3GPP TSG RAN Meeting #28

Title Summary of TTCN CR F category to 34.123-3

for approval Batch 2

Source RAN WG5

26.6 cr_TP_SUBMIT_04_VPF_ABS

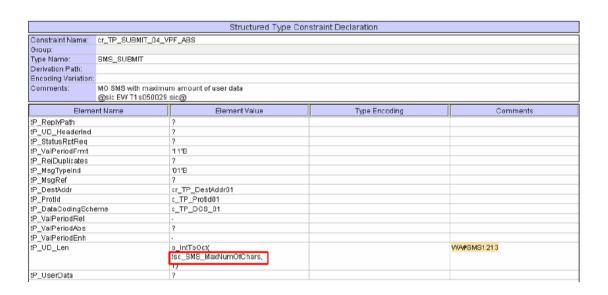
Reason for change Max number of ASCII characters in an SMS can be set by a constant rather
